Re: 251264
REUNION AT BLACKWELL

Reviewed Revise and Resubmit
 Reviewed as Noted Rejected
 Not required by the Contract Documents
 For Record Only

By: thult
Date: 10/15/2025

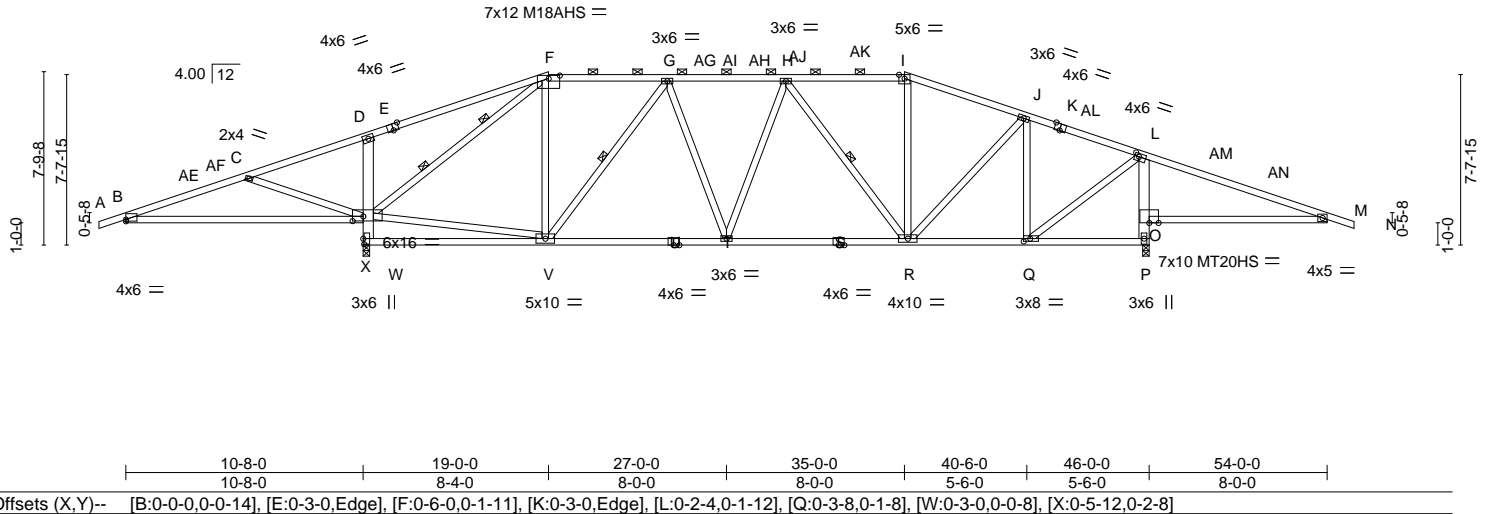
- 8) Provide mechanical connection (by others) of truss to be **CONTRACTOR TO INSTALL (2) H2.5A CONNECTORS AT EACH LOCATION** uplift at joint(s) except (jt=lb)

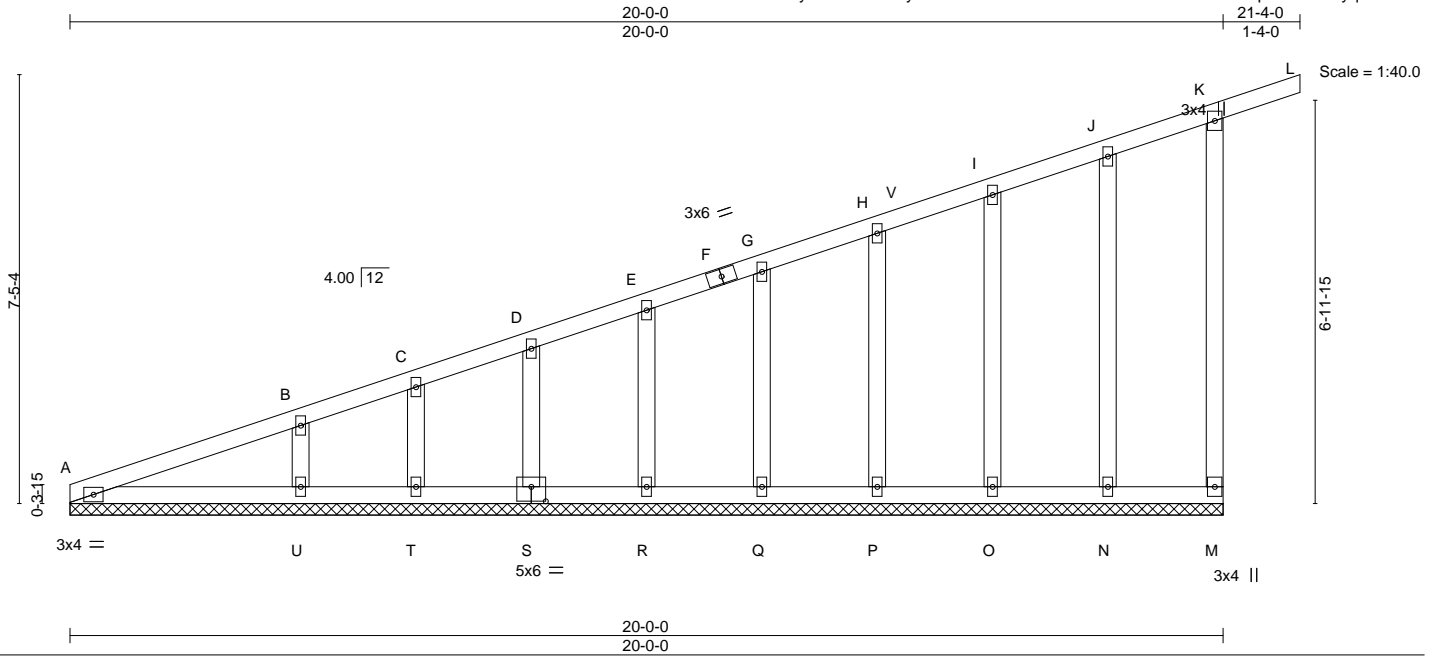
CONTRACTOR TO PROVIDE OUT OF PLANE BRACING, RE: 1/S061

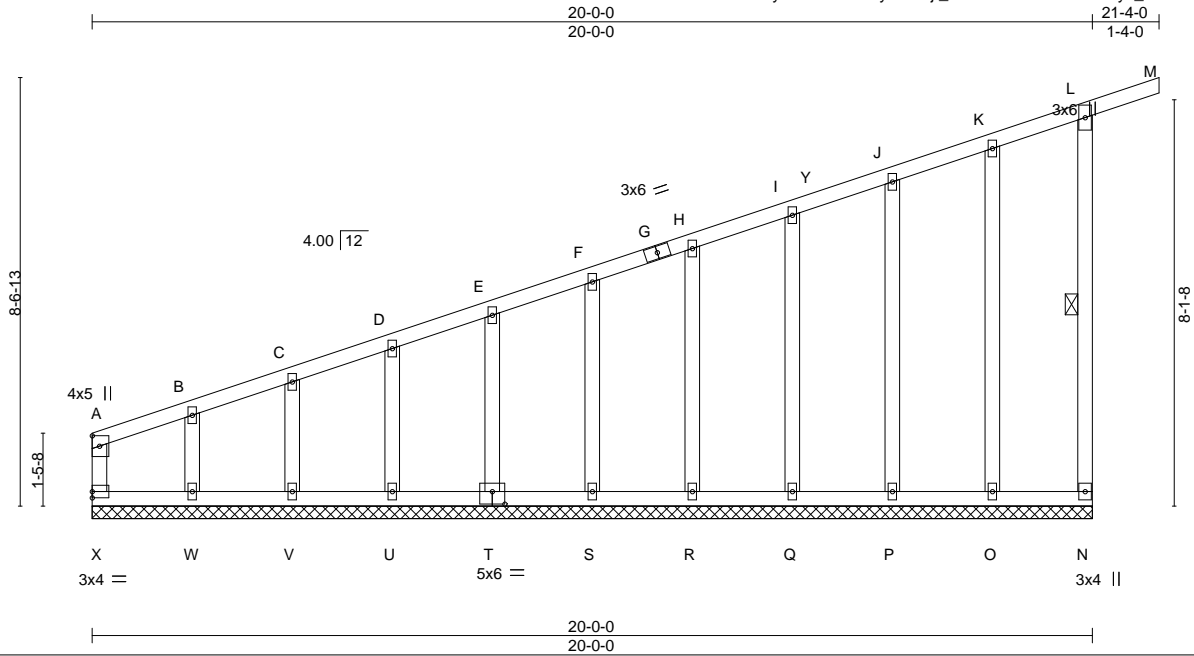
CONTRACTOR TO PROVIDE
OUT OF PLANE BRACING, RE:
1/S061

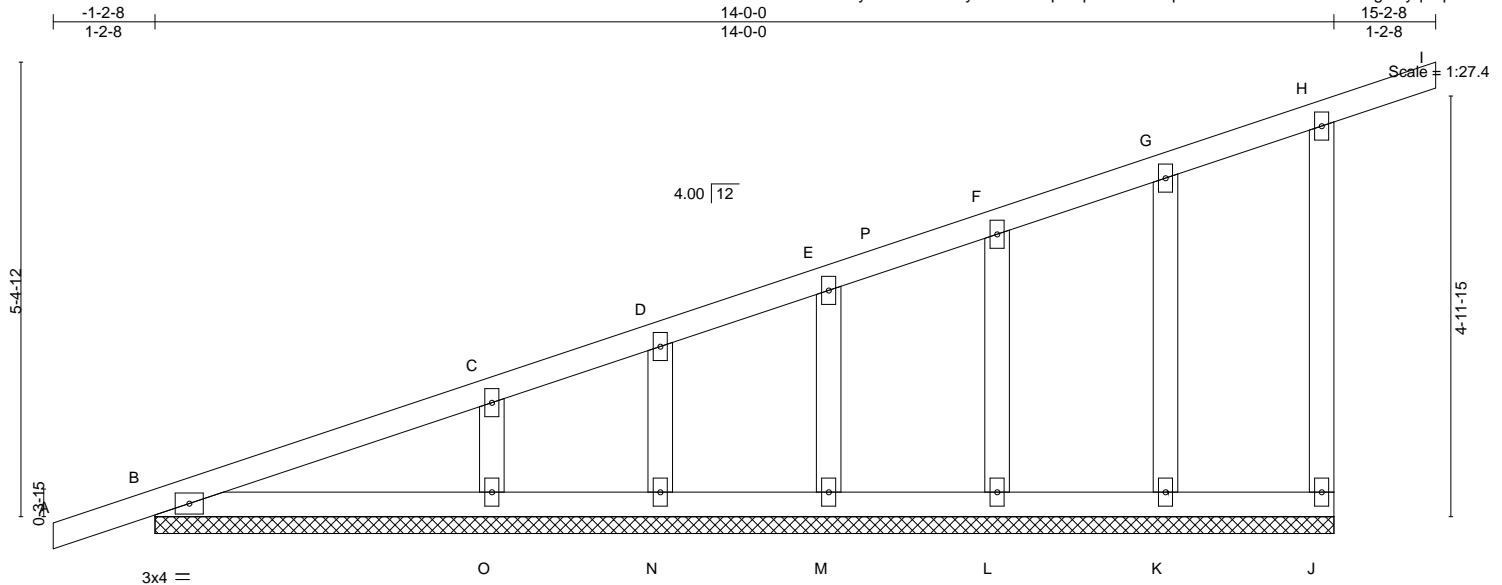
**CONTRACTOR TO PROVIDE
OUT OF PLANE BRACING, RE:
1/S061**

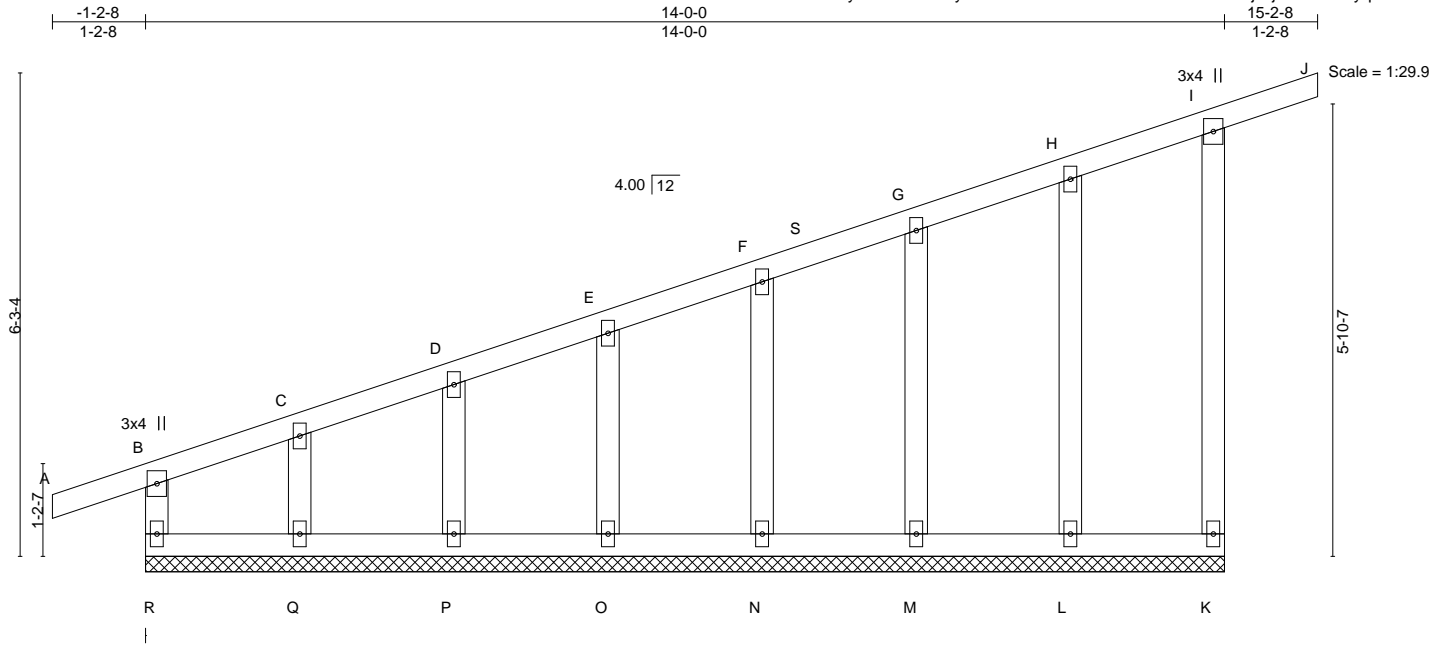
CONTRACTOR TO PROVIDE OUT OF PLANE BRACING, RE: 1/S061
